RE: RC Components Frame Recall

Reason for this Recall

EXHIBIT A

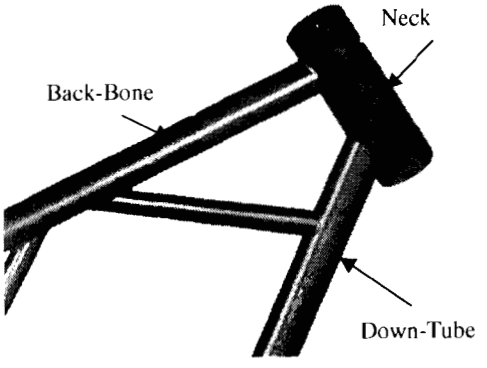
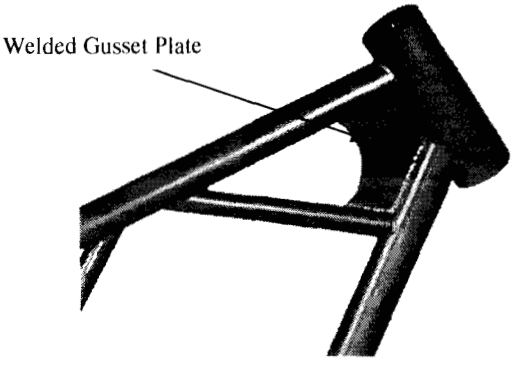
RC Components has decided that a defect exists in certain single down tube chopper frames it manufactured between January 2003 and September 2005, which did not include a factory-installed welded gusset plate connecting the frame backbone, neck and down tube (see Exhibit A1) and to which no gusset was added post-manufacture. Our records indicate you purchased a frame included in the recall group directly from RC Components.

These frames may have been subject to a breach during the manufacturing process, resulting in the possibility of rapid wear on the weld joints and possible joint separation. Cracks in the area of the weld joint may indicate unusual stress on the frame. If weld joint separation occurs while riding, the operator could lose control of the motorcycle resulting in a crash.

The remedy of the defect is to weld a gusset to the frame. The gusset is a steel plate shaped to ensure connection between the back-bone, neck, and down-tube of the frame (see Exhibit A2). Questions and a set of written instructions can be received by e-mailing rcframe@rccomponents.com or calling (270) 842-6000 x-116.
